NOTICE OF  
CHANGE

MIL-STD-188-185  
NOTICE 1  
1 December 1997

INTEROPERABILITY OF UHF MILSATCOM DAMA CONTROL SYSTEM

FIGURE 2. 5-kHz frame format.

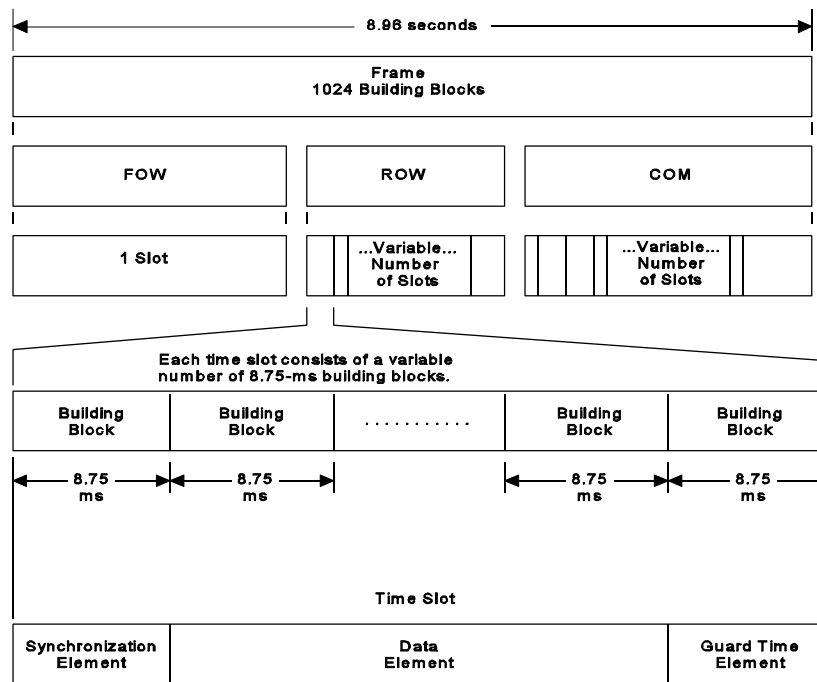
5.4.3.4.1 TDMA frame alignment. Time-division multiple access (TDMA) frames for all 5-kHz DAMA channels on all satellites in a given coverage area shall be aligned within 625 Fsec. TDMA frames for all 25-kHz DAMA channels on all satellites in a given coverage area shall be aligned within 104 Fsec. *Frame alignment* is defined as the synchronous arrival at the satellites of the start of the forward orderwire (FOW) or channel control orderwire (CCOW) preamble for all channels. All PCCs shall adjust their transmission times, as a function of their changing satellite range, to ensure that the preamble arrives at the satellite within the specified time limit. Frame alignment shall be maintained even when channel control is divided between control stations. There is no alignment requirement between 5-kHz and 25-kHz TDMA frames. See 6.3.1 for discussion of the need for frame alignment.

5.4.3.4.2 TDMA frame-length accuracy. The maximum offset from true time of the arrival at the satellite of the start of every 5-kHz FOW preamble during a 24-hour period shall not be greater than 1 millisecond (ms). The maximum variation offset from true time of arrival at the satellite of the start of every 25-kHz CCOW preamble during a 24-hour period shall not be greater than 100 microseconds (Fs). *True time* is defined as the perfectly timed arrival of the FOW/CCOW at the satellite and requires perfect ranging and perfect clock accuracy. See 6.3.2 for discussion of frame length.
